**INVITATION TO BID 2024-01
CITY OF PARKER
INLAND FLOOD PROTECTION RETENTION POND AND WALKING PATH**

**ADDENDUM NO. 2
REQUESTS FOR INFORMATION**

Issued March 14, 2024

Sheet No.
C1.2

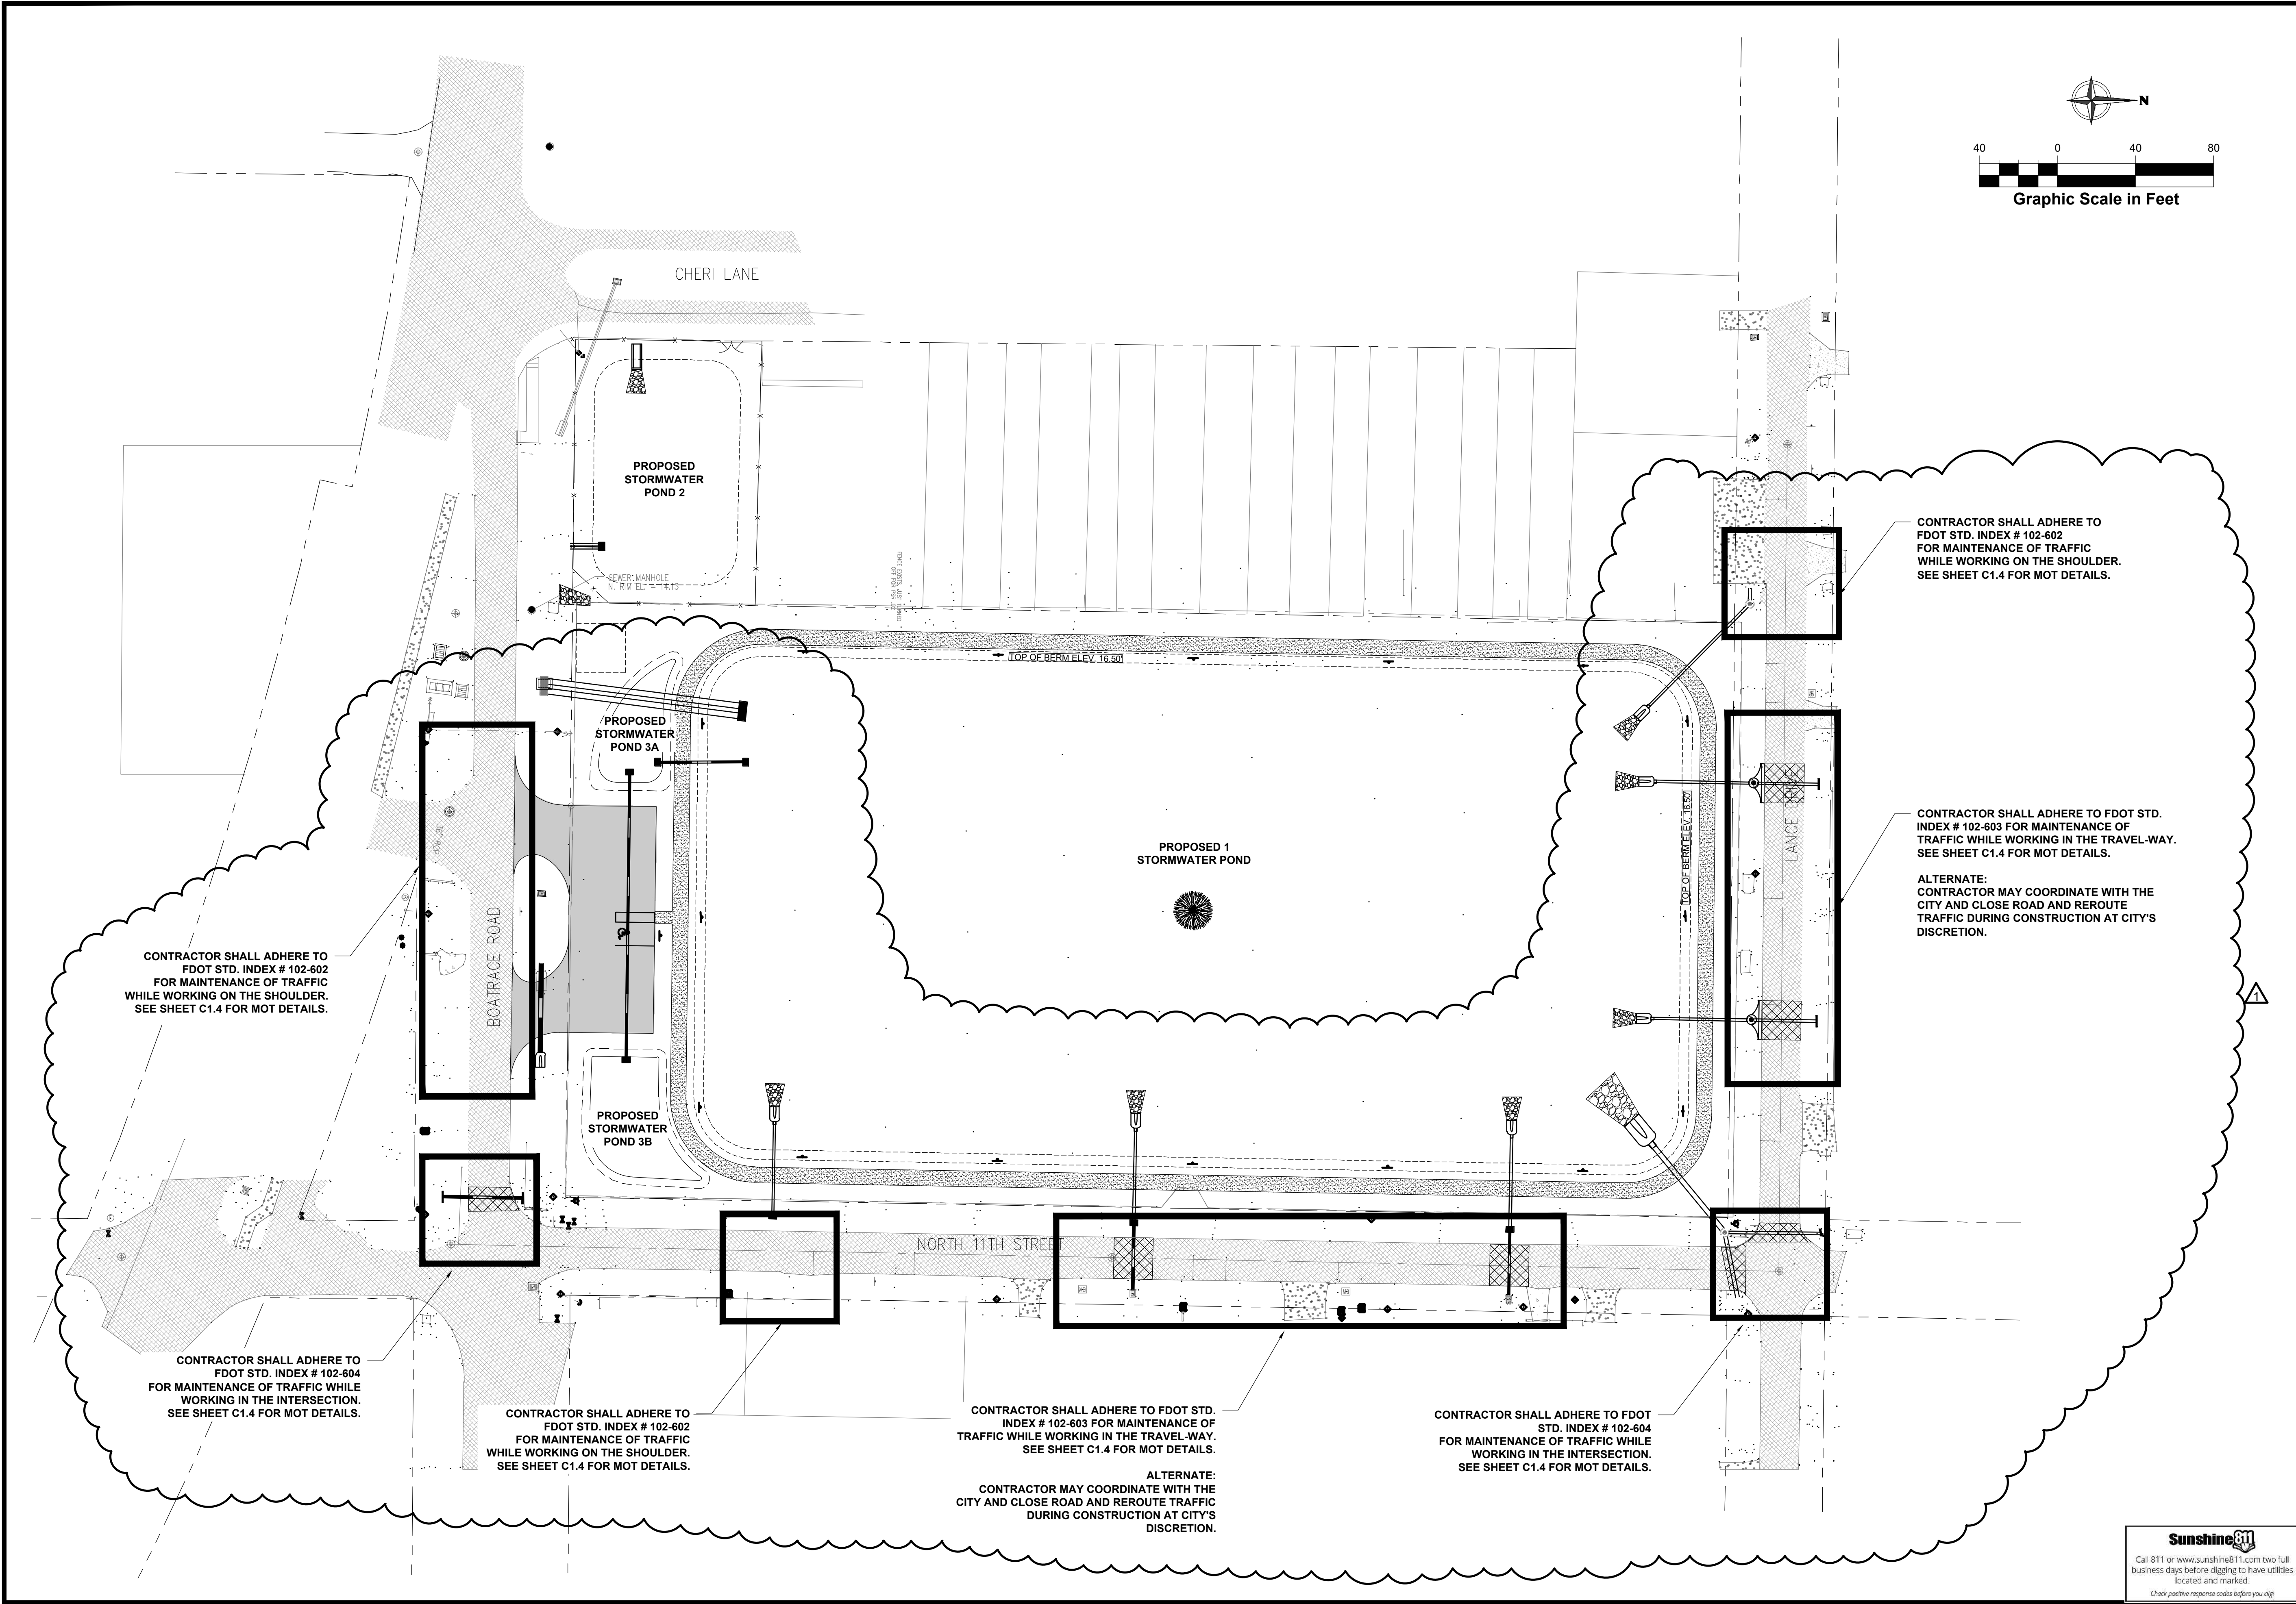
Clarification: The ditch bottom inlets shown on SHEET C1.2 have been revised to accurately reflect the FDOT Type of inlet required.

All Type C ditch bottom inlets will have grates. The Modified Type D discharge structure is with a grated top and skimmer.

ALTERNATE ASPHALT WALK DETAIL

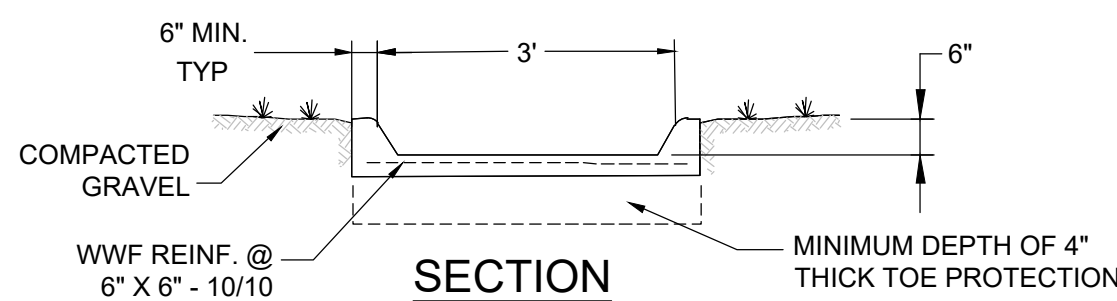
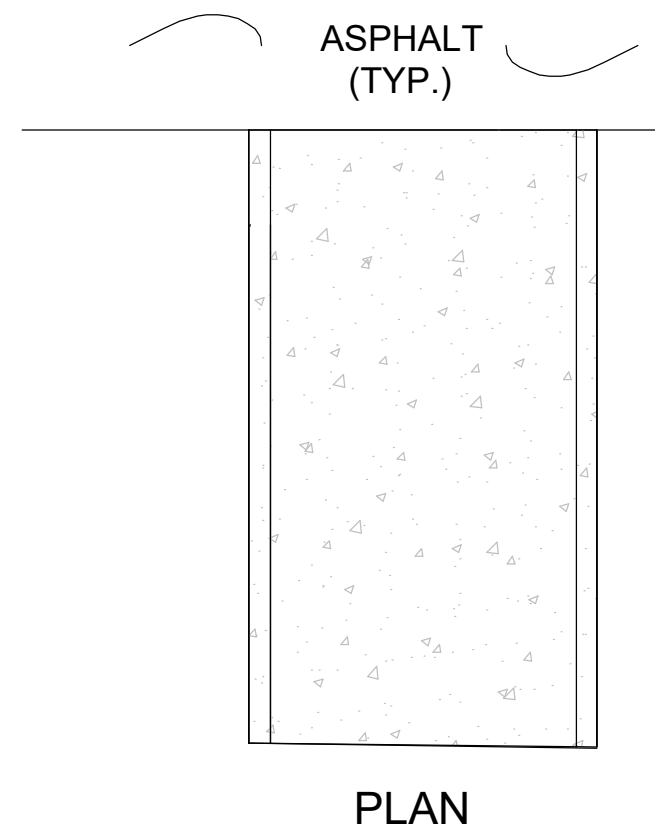
RAI No. 2. Could you take a look at the Asphalt Trail alternate. The detail does not call for any base and you cannot lay asphalt on subgrade. Also, would you allow the trail to be 8-foot-wide as that is as narrow as the paver will get.

The Alternate Asphalt Walk Detail on SHEET C2.1 has been revised to show an 8-foot asphalt walking path, a 12-inch subgrade, a 6-inch limerock base, with a 1-1/2-inch asphalt overlay.

- ALTERNATE ASPHALT WALK DETAIL**
- N.T.S.
- (A) 1-1/2 INCH TYPE SP 9.5 ASPHALTIC CONCRETE
- (B) 6 INCHES LIMEROCK/CRUSHED CONCRETE BASE COMPACT TO 98% MOD. PROCTOR MAX. DRY DENSITY (AASHTO T-180; ASTM D-1557). MIN. LBR = 100.
- (C) 12 INCHES STABILIZED SUB-GRADE COMPACTED TO 98% OF MOD. PROCTOR MAX. DRY DENSITY (AASHTO T-180; ASTM D-1557) MIN. LBR=40
